**REVISED REQUEST FOR CHANGES TO THE QUALITY ASSURANCE PROGRAM
HOPE CREEK AND SALEM GENERATING STATIONS
FACILITY OPERATING LICENSES DPR-70, DPR-75, AND NPF-57
DOCKET NOS. 50-272, 50-311, AND 50-354**

**HOPE CREEK GENERATION STATION AND
SALEM GENERATING STATION UNIT NOS. 1 AND 2
FACILITY OPERATING LICENSES NPF-57, DPR-70, AND DPR-75
DOCKET NOS. 50-354, 50-272, AND 50-311
REQUEST FOR CHANGES TO THE QUALITY ASSURANCE PROGRAM**

RESPONSES TO NRC STAFF QUESTIONS

PROPOSED HOPE CREEK UFSAR CHANGES

PUBLIC SERVICE ELECTRIC AND GAS COMPANY HOPE CREEK GENERATING STATION	
QUALITY, NUCLEAR TRAINING & EMERGENCY PREPAREDNESS	
Updated FSAR Revision 9, June 13, 1998	Sheet 1 of 1 Figure 17.2-1

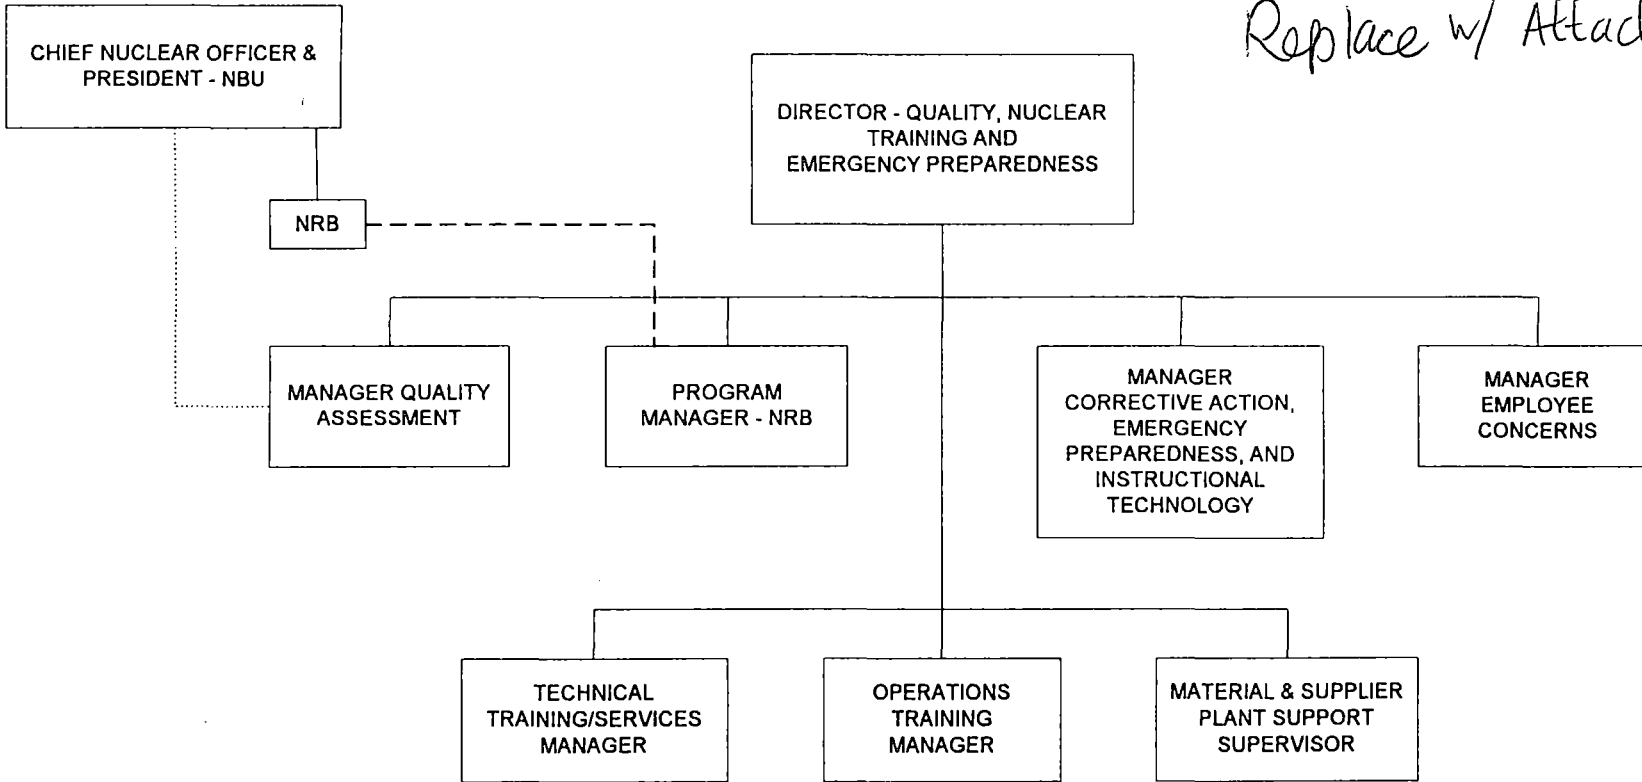
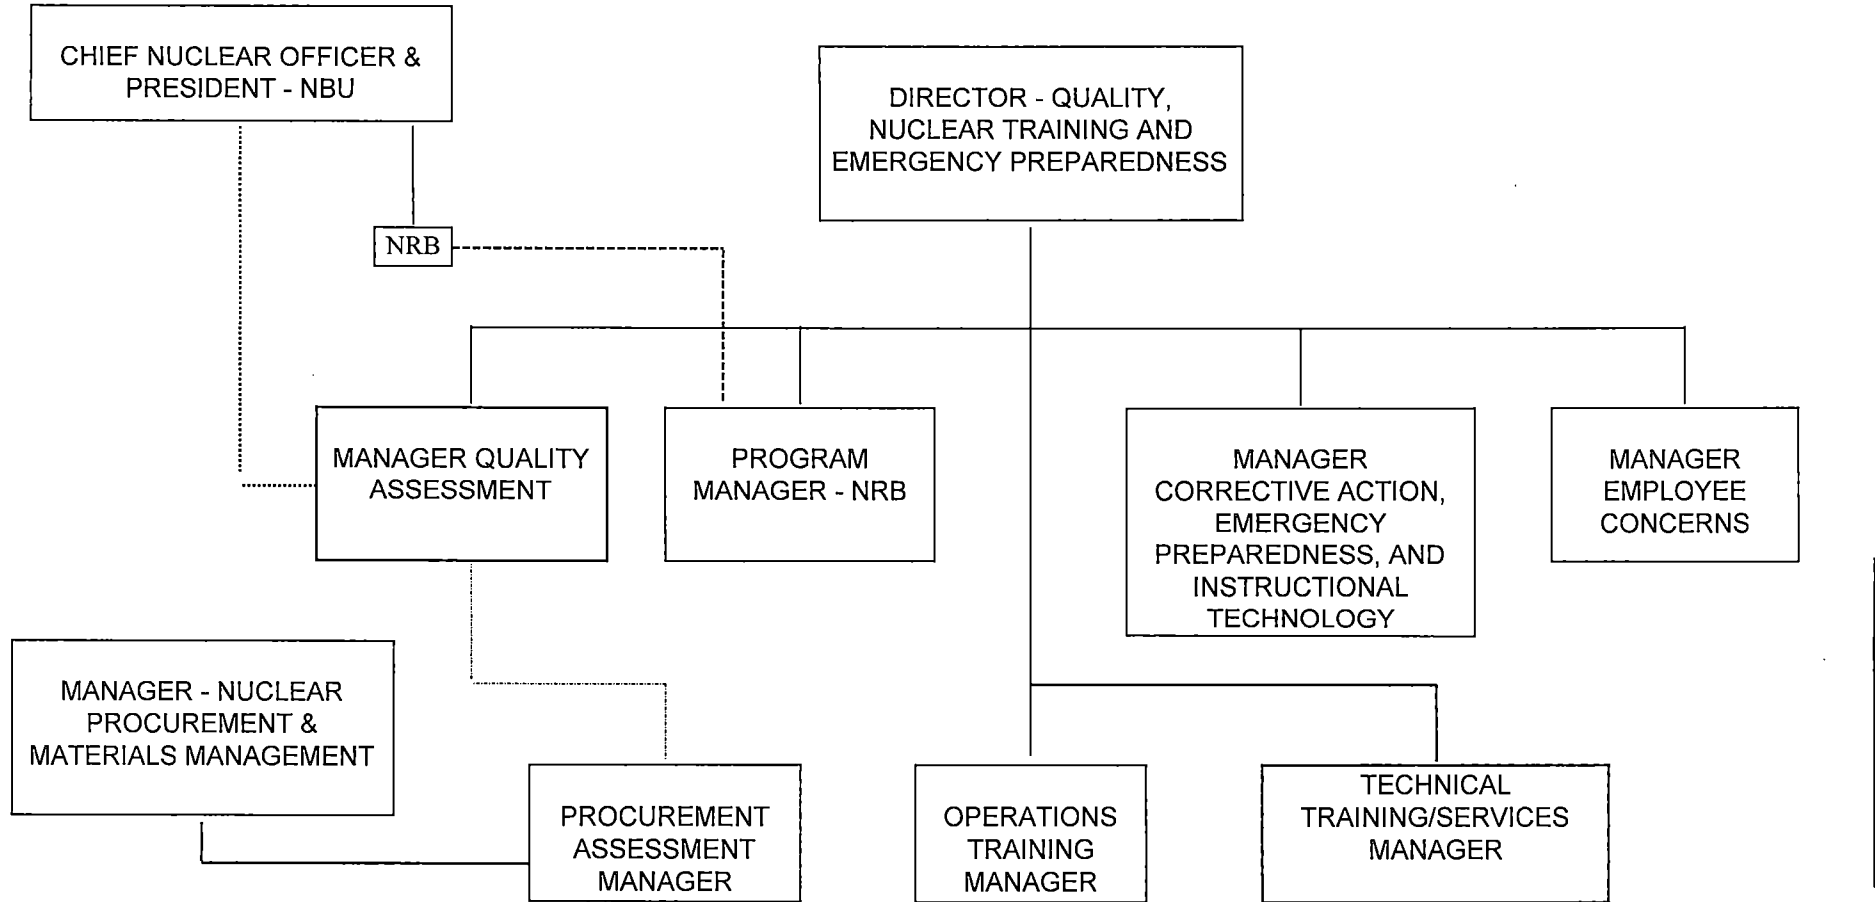
Replace w/ Attached

Figure 17.2-1
 Sheet 1 of 1

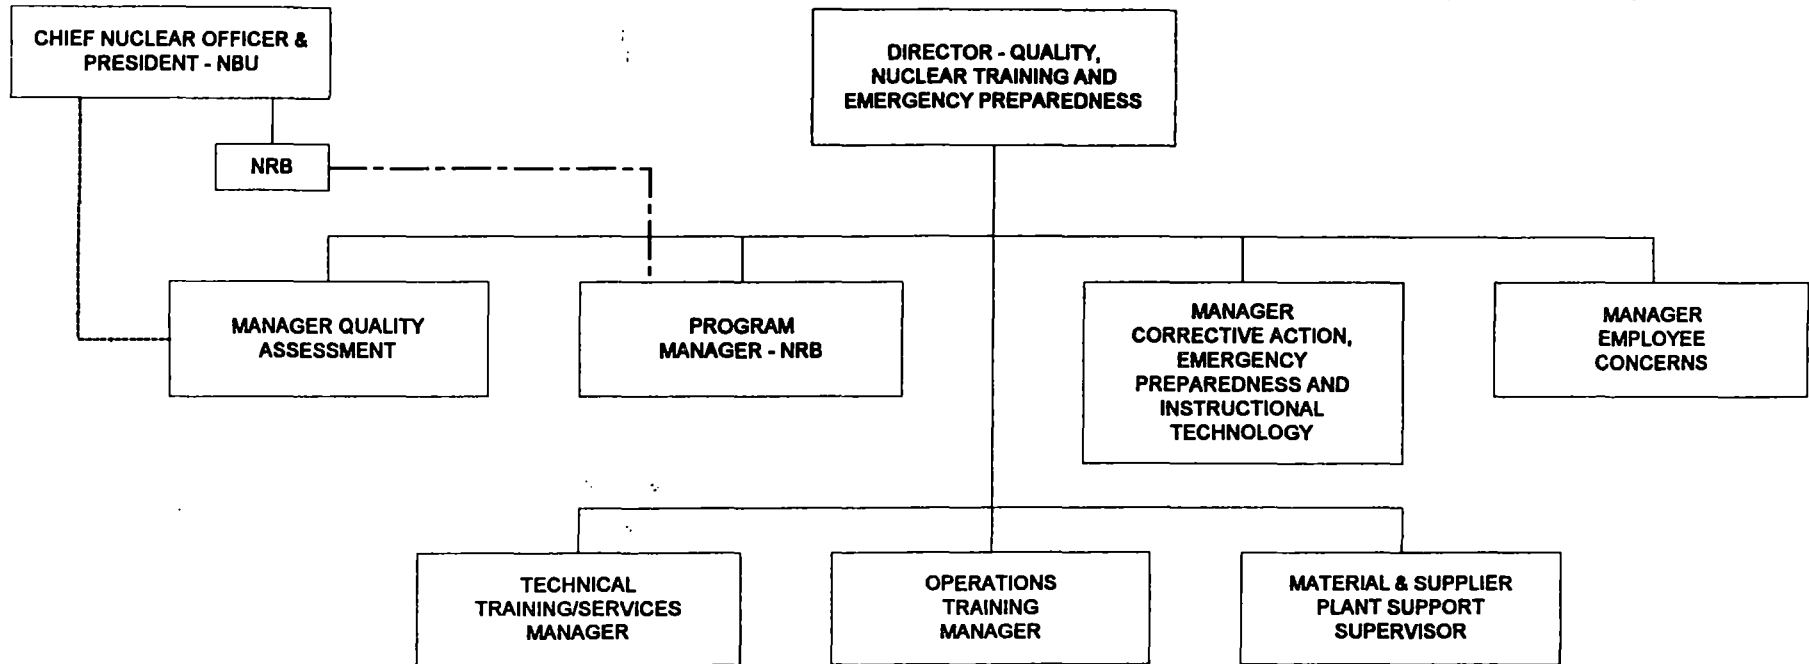
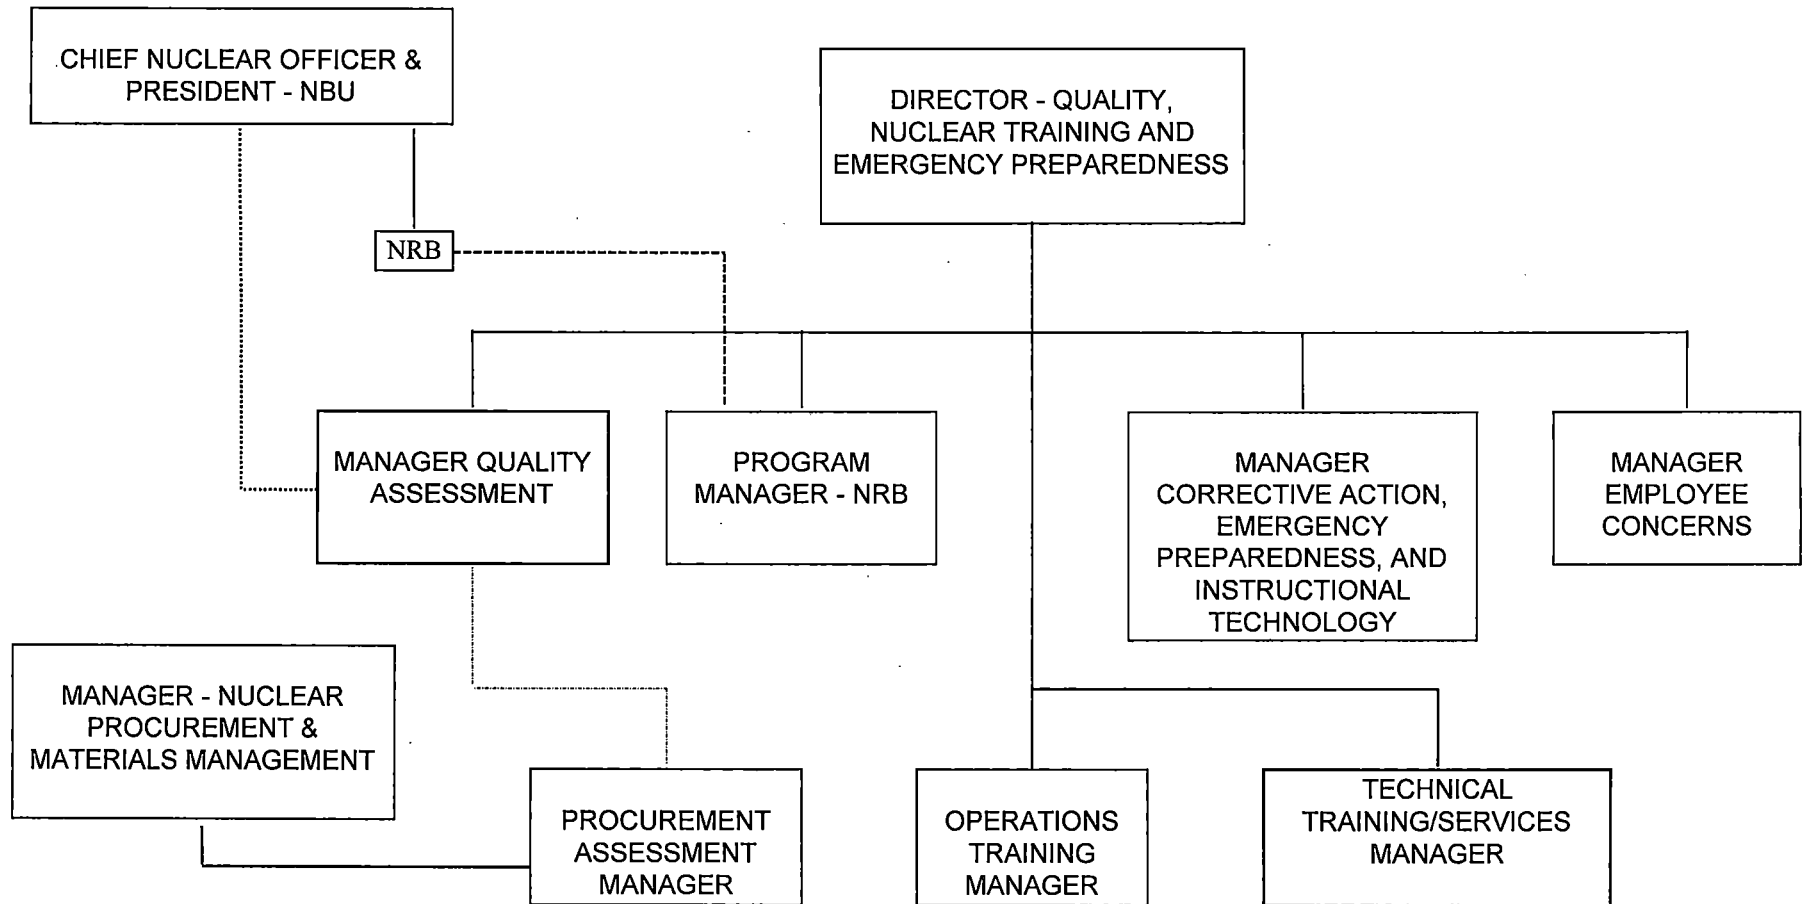
Replace w/ attached
